Patent No.: 7,428,260

For: UNIFIED MMSE EQUALIZATION AND
MULTI-USER DETECTION APPROACH FOR
USE IN A CDMA SYSTEM

**REQUEST FOR CERTIFICATE OF CORRECTION
PURSUANT TO 37 CFR 1.323**

Fig. 2

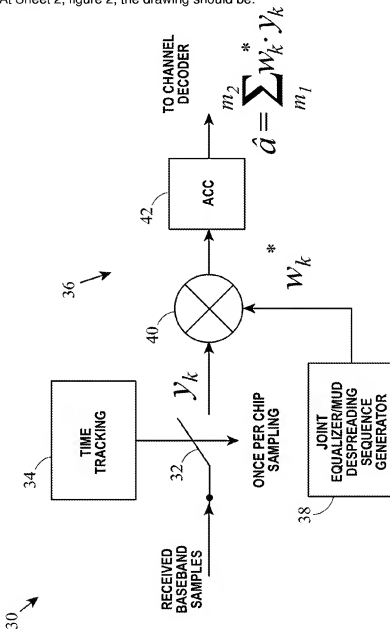
With regard to Sheet 2, Fig. 2 in the drawings, it appears that the Office published the annotated sheet instead of the replacement sheet submitted with the Amendment dated August 9, 2007.

At Sheet 2, figure 2, the drawing should be:
